From: Renee Irish <renee.irish@gmail.com>
Sent: Thursday, April 04, 2013 6:45 PM
To: Bradley Kilby
Subject: SUB13-01 DR Horton Daybreak Subdivision

Subject: Daybreak Subdivision, SUB13-01, 2S130CC00300, 00500

To:	Brad Kilby, Planning Manager
From:	Craig Christensen, P.E., Engineering Associate II
Project:	(SUB 13-01) Daybreak Subdivision by DR Horton
Date:	April 15, 2013

RE: **DR Horton - Daybreak 36 Lot Residential Subdivision**
City File Number: **SUB 13-01**
County File Number: **CP-17*
Tax Map and Lot Number: **2S130CC 300/500**
Location: **21730/21500 SW Elwert Road**

PRELIMINARY SUBDIVISIION PLAT

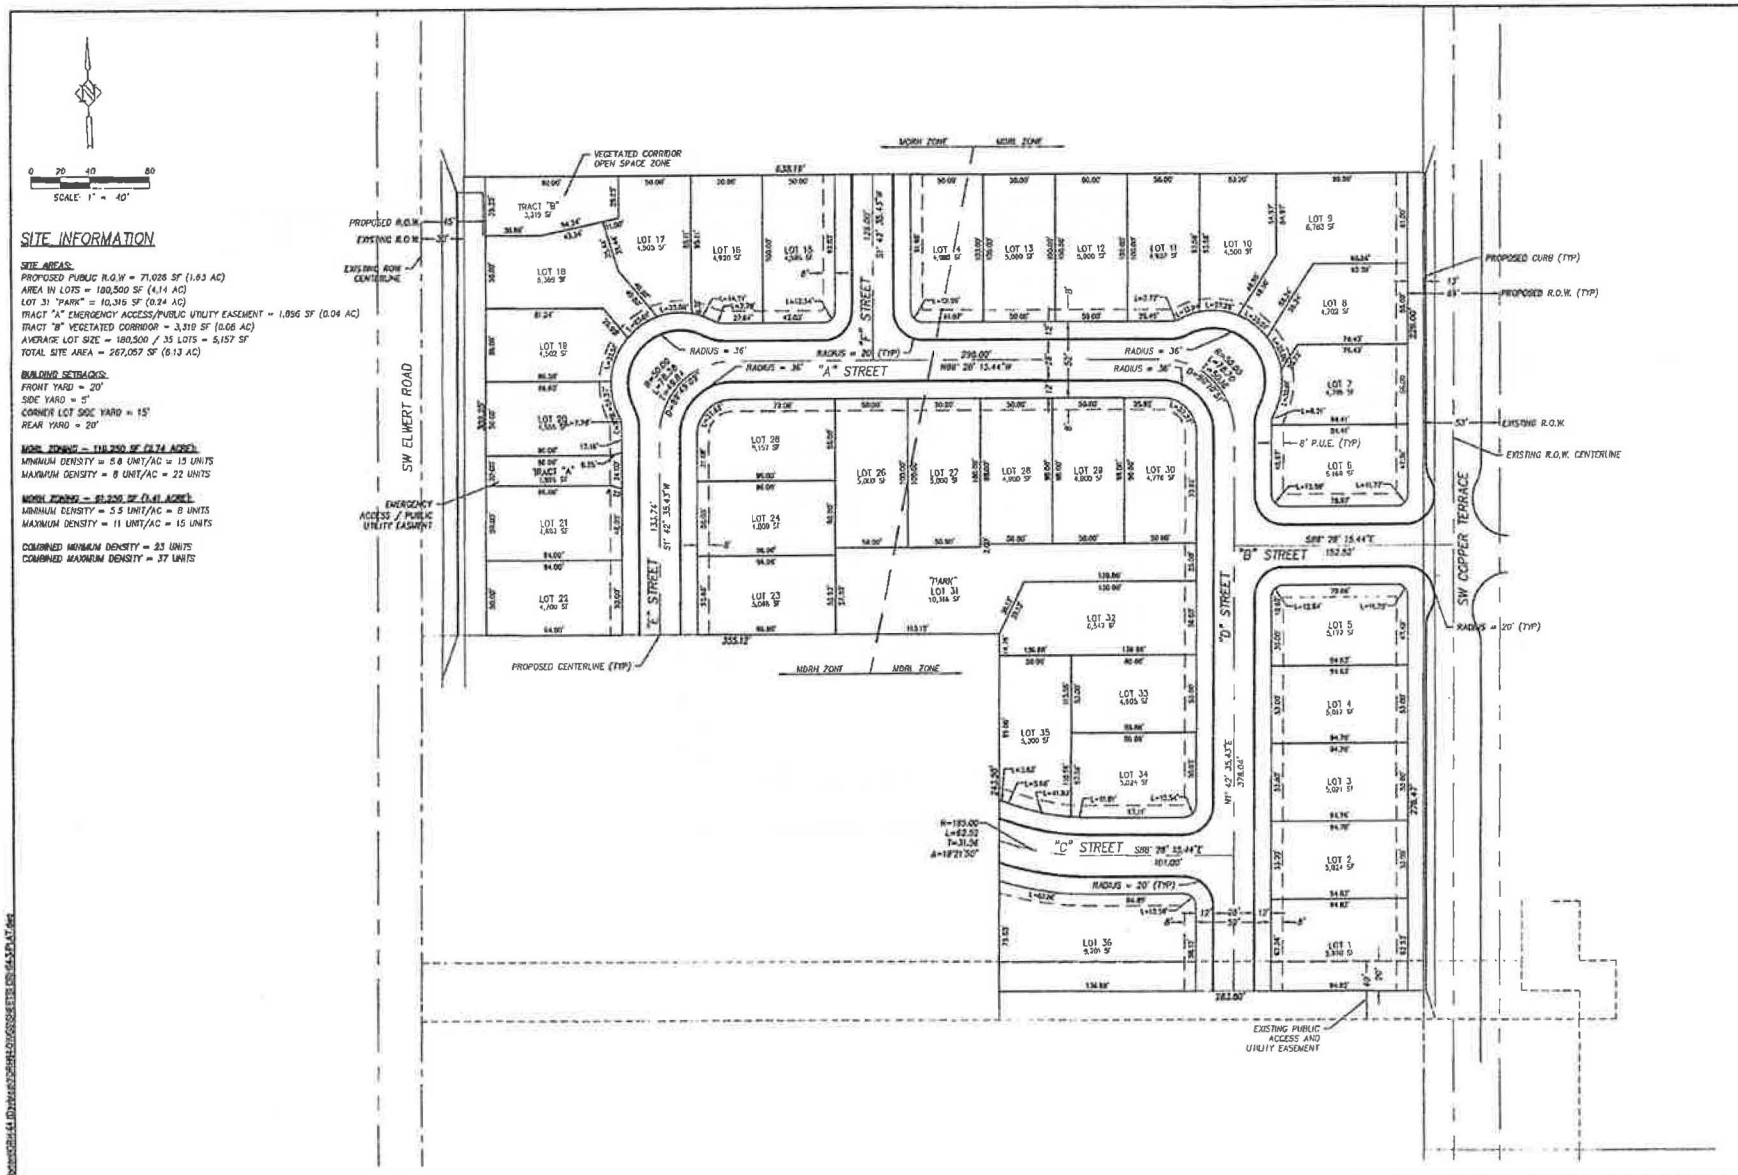
#1) Streets "C" & "E" appear to "dead end" &/or run directly into our property @ 21710 S.W. Elwert Rd; we assume that barriers will be in place to stop traffic from continuing onto our property.

#2) The unimproved gravel roadway from Elwert Rd that allows us the only access to our 21710 property (as well as the back of our 21820 property), and potentially a couple of development lots & Street "D" is not intended to be used as an access for the development from Elwert Road &/or Copper Terrace. Again, we are assuming that a barrier will be put in place to stop traffic from Street "D" and a fence be constructed (referenced below) separating the development from this gravel roadway.

1) **DEAD END ROADS:** Dead end fire apparatus access roads in excess of 150 feet in length shall be provided with an approved turnaround. (OFC 503.2.5) ***The turn- around shown represented as "Tract A" on plans submitted is acceptable to meet this condition.***

A maintenance access road shall be constructed within Tract "A" and shall have a 4-foot high by 20-foot wide double tubular barrier gate with a Knox Box a minimum of 30 feet back from intersecting roadways. The road within Tract "A" shall serve as an emergency access road meeting Tualatin Valley Fire and Rescue approval until such a time as the property to the south develops in a manner that eliminates the need for Tract "A" to be used as an emergency vehicle access. Tract "A" shall be dedicated to the City of Sherwood. Turning movements into Tract "A" at both intersections shall meet Tualatin Valley Fire and Rescue requirements.

ELWERT ROAD HALF-STREET TYPICAL SECTION

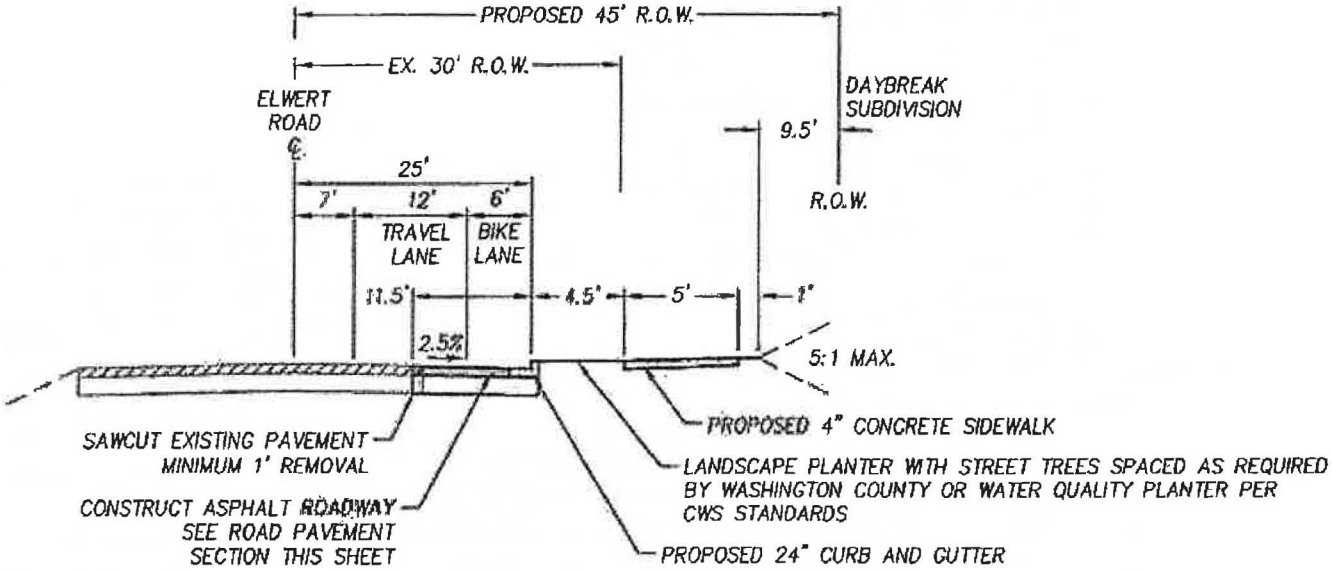
Construction of a half-street (sidewalk, curb, and gutter) to an A-4 County standard, including illumination, is required along the subject site's frontage of SW Elwert Road.

The applicant is required to dedicate additional right-of-way to provide 45 feet from the centerline of SW Elwert Road.

Washington County Department of Land Use and Transportation has reviewed the proposed development and submitted comments dated March 28, 2013. The county will defer to the city's standards for the sidewalk width along the frontage of SW Elwert Road. All other public improvements proposed within SW Elwert Road right-of-way are required to comply with county design/construction standards.
